ADDENDUM NUMBER 3

Issued: January 10, 2013

**SONOMA VALLEY COUNTY SANITATION DISTRICT
BIOSOLIDS MANAGEMENT UPGRADE**

SVCSO BIOSOLIDS MANAGEMENT UPGRADE		DRAWING NUMBER: S-03	
MISCELLANEOUS CONCRETE DETAILS		SHEET 18 OF 49	
FILE NAME:	4051_STRUCTURAL_GEN-DETAILS	CONTRACT NUMBER:	70-712-7#2

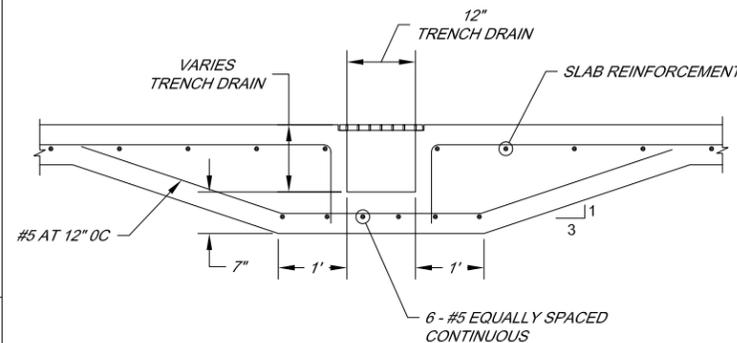
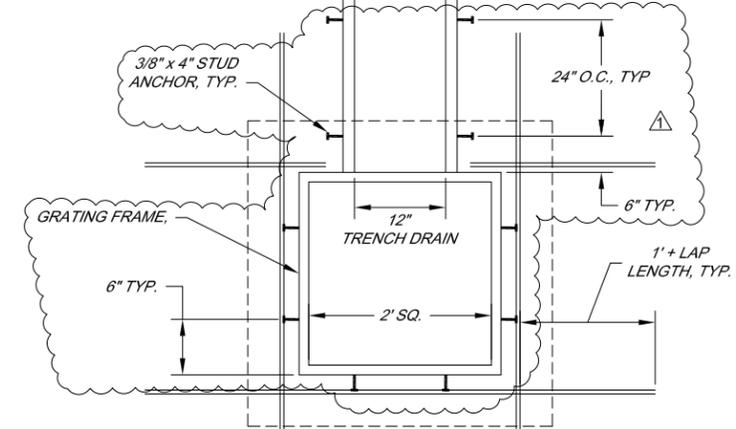
1. Drawing S-05 shows a trench drain and catch basin with callouts to details 1 and 3 on S-03. Detail 1 on S-03 calls for FRP grating at the catch basin. Detail 3 does not clarify what

type of grating is required at the trench drain, is this also FRP? The specifications do not include a division 6, which typically lists FRP grating requirement. Can you provide detail on the requirements for the FRP grating at the catch basin (and trench drain if required). Can you also clarify if there is any type of embedded support required for the grating, and whether it is FRP or metal.

3. Trench drain and catch basin grate.

G. Trench drain and catch basin grate:

1. Bearing bars: 1 1/2" x 3/8" mild steel placed at 15/16" on center.
2. Cross bars: 4" on center
3. Ends: banded with 1 1/2" x 3/8" mild steel bars
4. Finish: hot-dipped galvanized
